Coordination transmittal and sheet index

Orion Biologics | Suite 214 laboratory renovation | record package

RFI-214-17 - Lab B corridor opening

Field response and marked plan excerpt

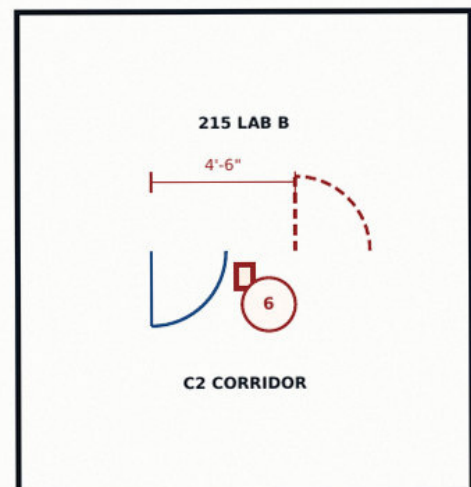
Revision B opening conflicts with the installed security rough-in. Confirm governing opening, swing, reader jamb, controller branch, and whether the old field background may be used for set-out.

VOID D-214A SET-OUT.

Shift opening 4'-6" west.

Use D-214B; swing south into C2.

Set CR-6 on corridor-side east jamb.

DC-6 branch is LP-2 / L2-15.

Revision C governs construction.
